**TO:** City Plan Board

**Item Number:** 1

**DATE:** April 28, 2016

**SUBJECT:** Petition PB-16-25 SUP, Causseaux, Hewett & Walpole, agent for TBG Innovation Square LLC, owner. Special Use Permit with development plan review to allow the construction of a mixed-use development. Zoned: UMU-2 (10-100 units/acre, and up to 25 additional units/acre by special use permit, urban mixed-use district). Located at 805-819 W University Avenue.

SHEET TITLE  
**BASEMENT PARKING GARAGE INTERIOR PHOTOMETRICS**

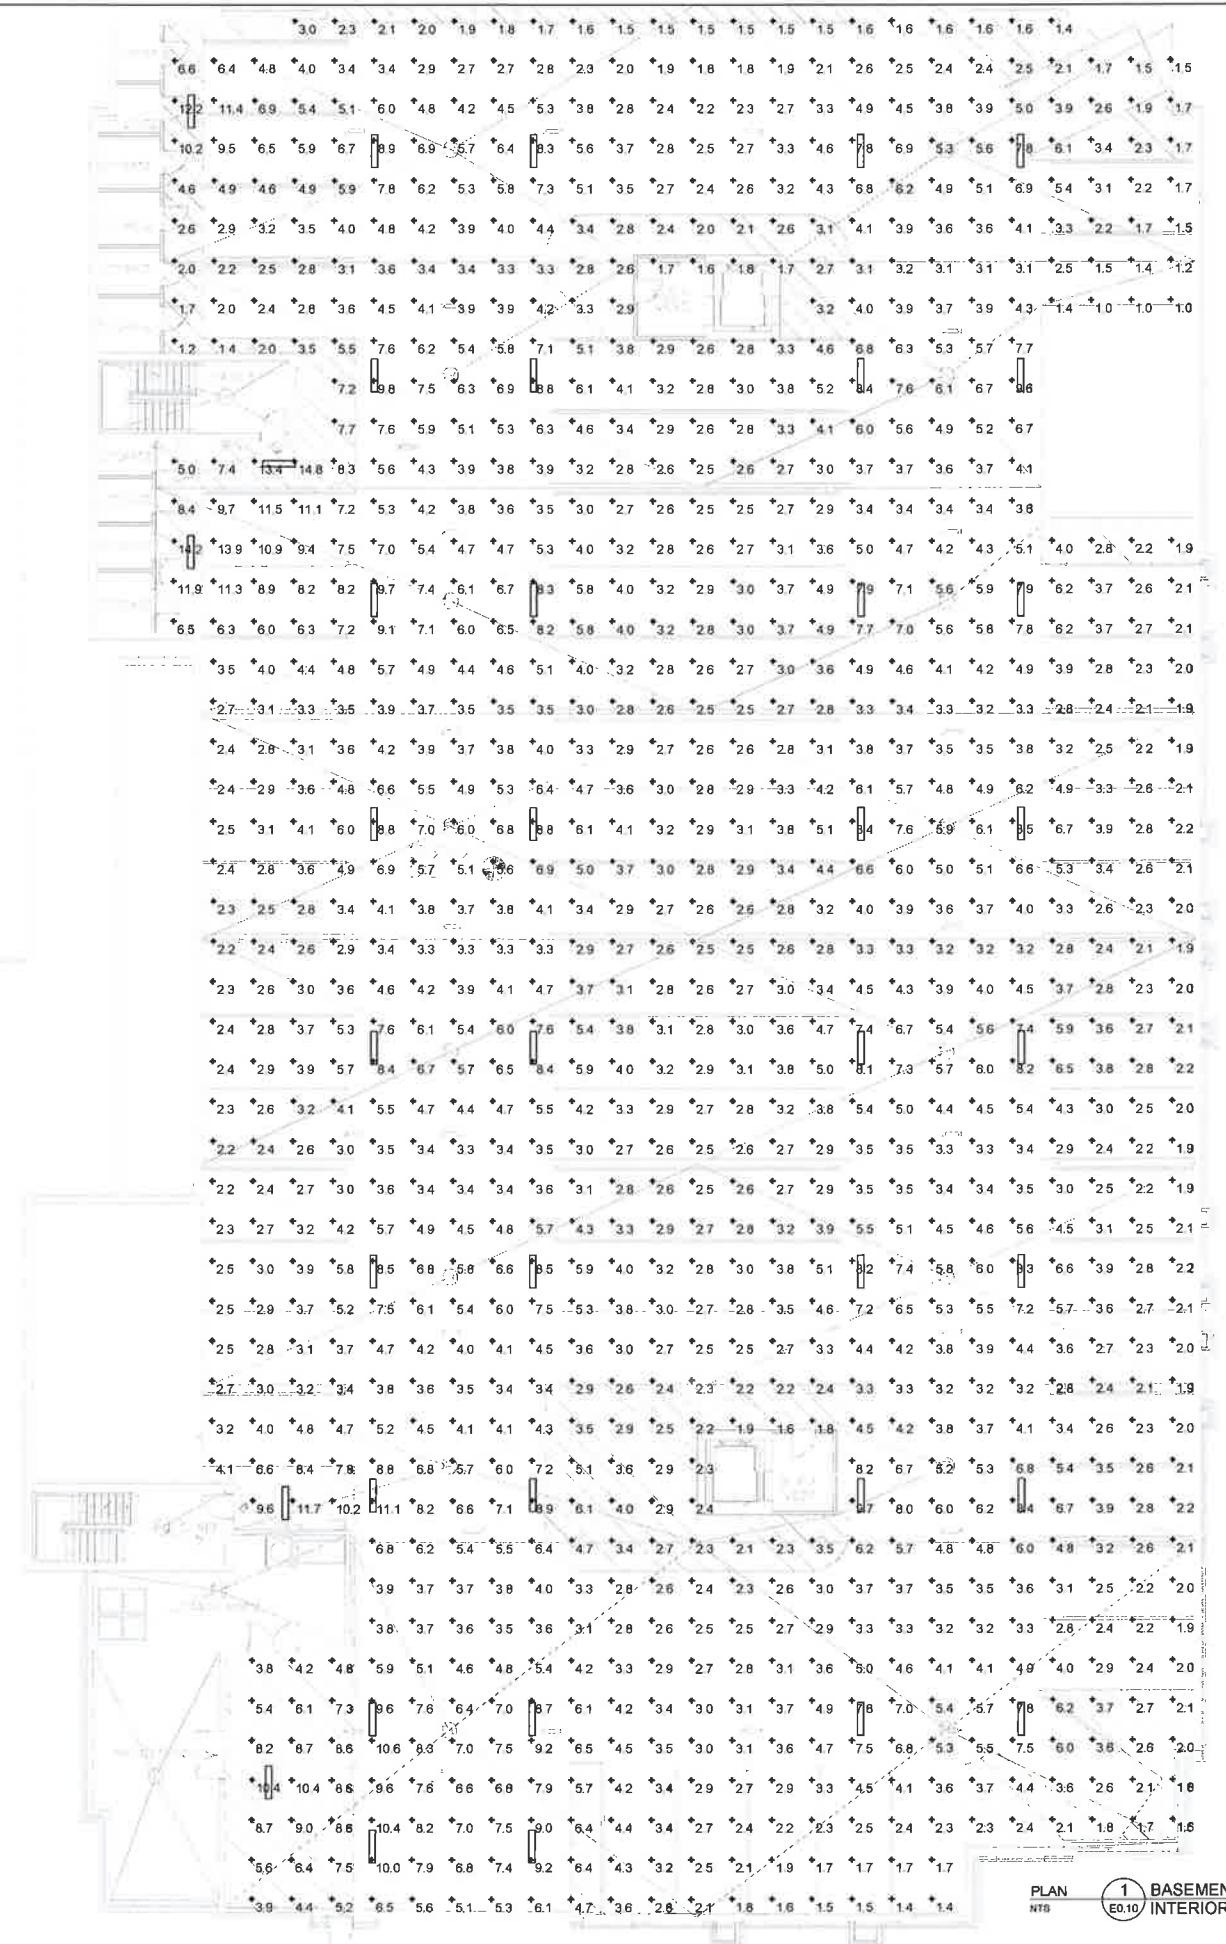
- ~~21.~~ The footcandle values on Sheet E0.01 are not legible. A larger scale is required.
22. A photometric narrative addressing the requirements in Sec. 30-344 of the LDC for the building exterior and parking garage shall be provided. Cut-sheets of proposed light fixtures are also required. Waivers from the City's lighting standards must be expressed in a letter to be included with the next development plan submittal on a designated cut-off date prior to public hearing.

PLAN 1 01 LEVEL T.O. SLAB  
1/16" = 1'-0"

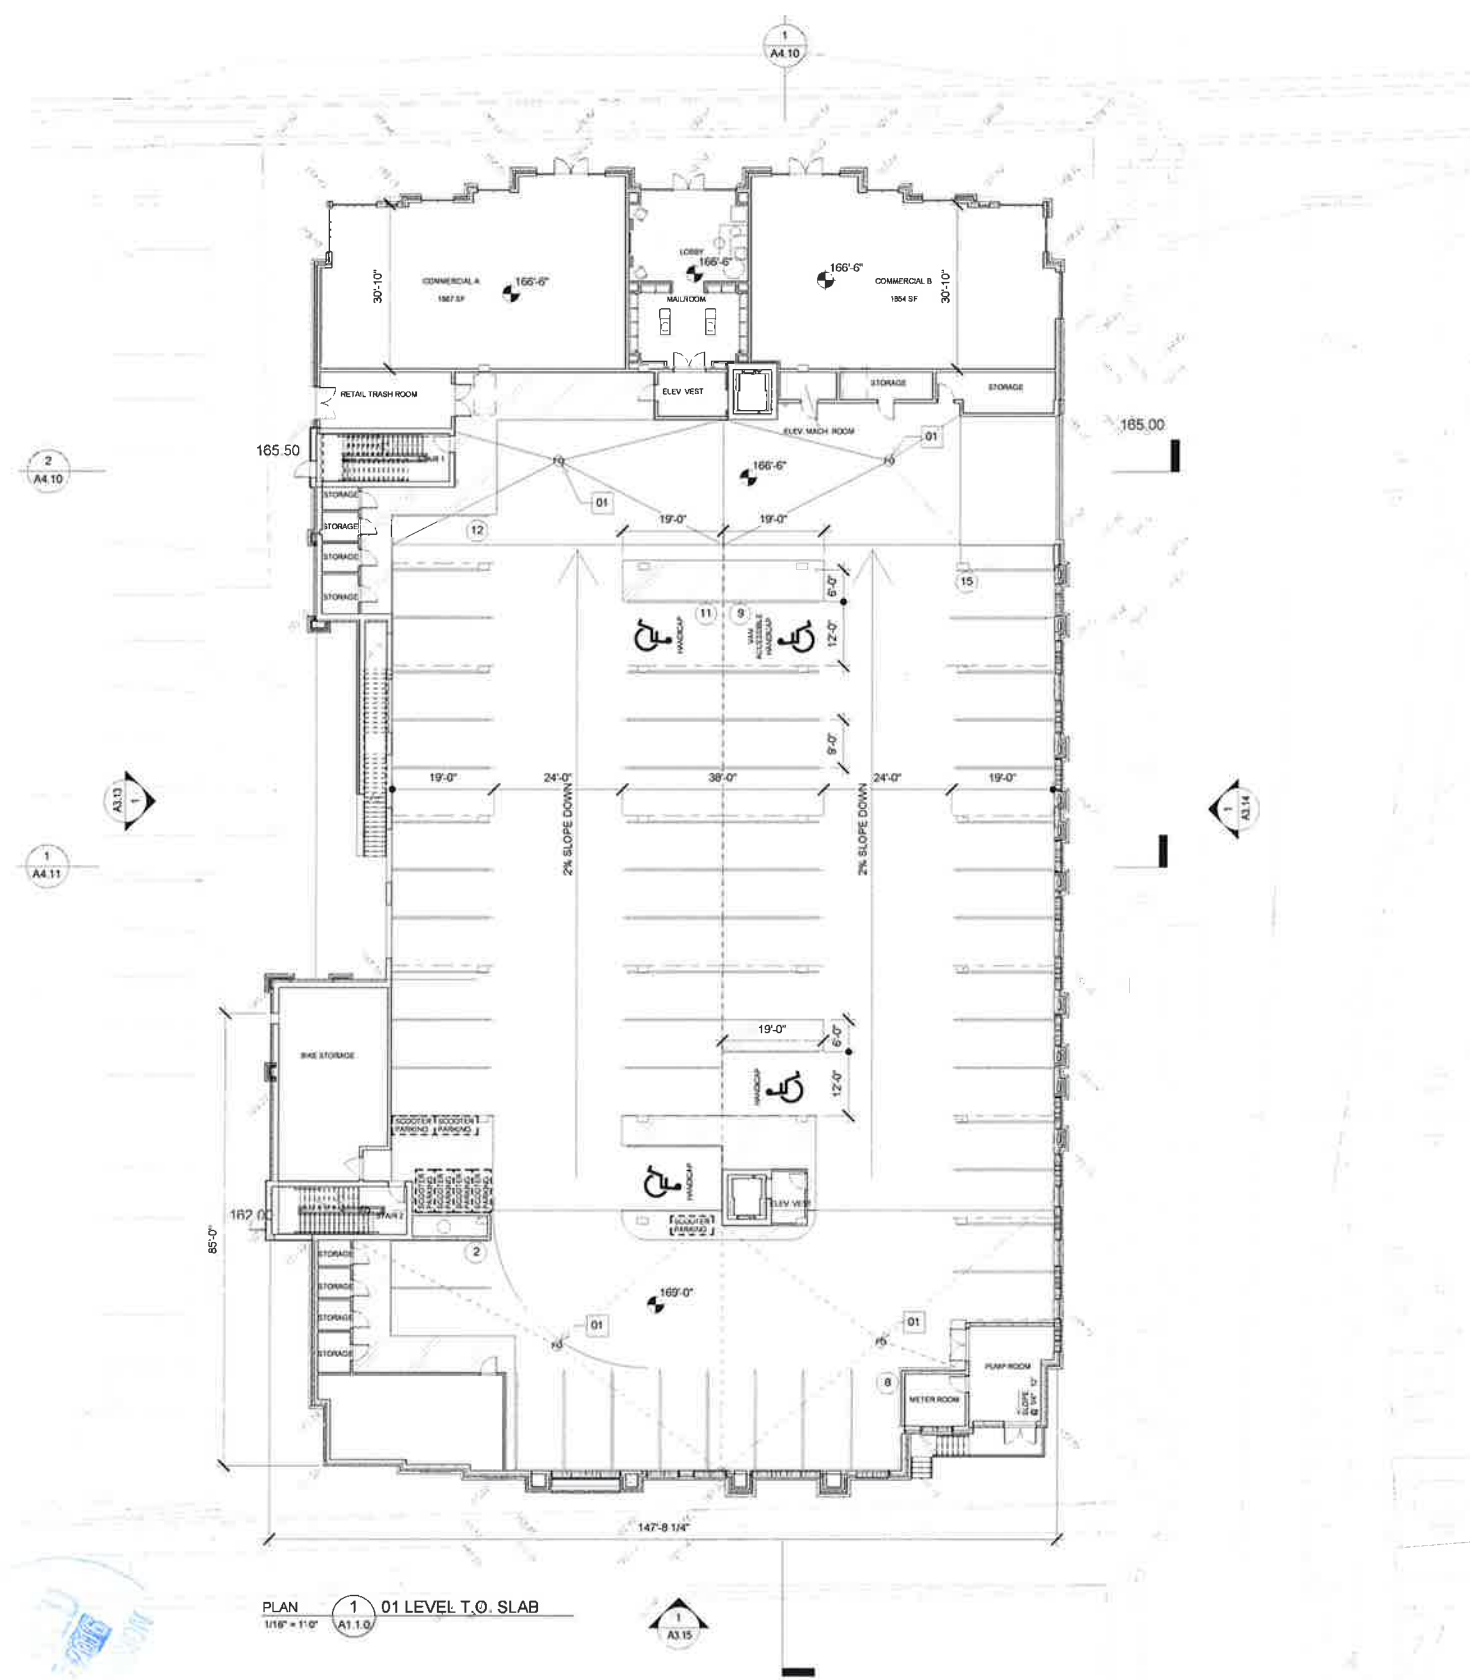
6. ~~Please provide dimension on Sheet A1.1.0 that shows compliance with 30 ft. active use requirement at the first floor level, per Figure 5.0, Sec. 30-65.2 of the City Land Development Code (LDC). Some sections of the first floor that face W. University Avenue appear to be less than 30 ft. in depth.~~
